Opel

Astra G Model year 2003–2004
Zafira Model year 2003–2004
Vectra C Model year 2002–2004
Signum Model year 2002–2004
With engines Y20DTH / Y22DTR

Malfunction of the EGR valve

Fig. 1

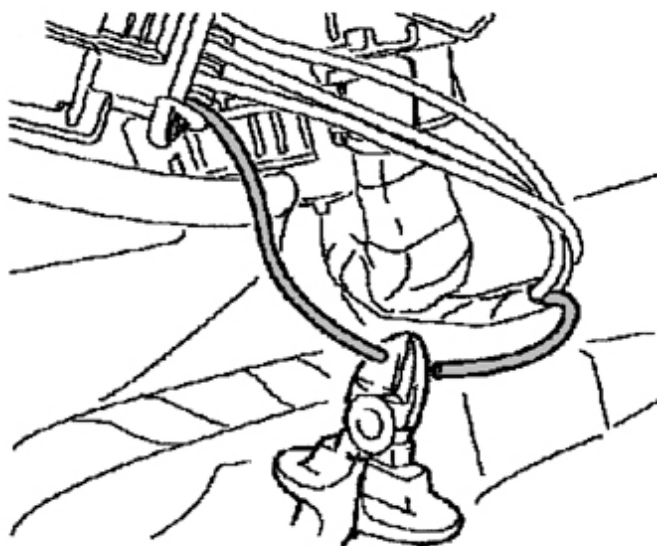
If there are complaints about the above-mentioned fault, the cause could be faulty contacting. Also, fault code P 0400 (C) and/or fault code P 0400 (9) are/is stored. In addition, the vehicle goes into "limp-home" mode.

In this case, an electrical contact on the EGR valve must be cut through.

- Cut through the cable (0.5 / grey-black) which leads from slot 4 on the electric EGR valve to connection 19 on the pump valve. Cut through the cable approx. 20 mm behind the plug of the EGR valve (see Fig. 1). In relation to this, on no account may the pump plug be loosened.
- After this, insulate the cable ends in a watertight manner and fasten to the cable loom using insulating tape (see Fig. 2).
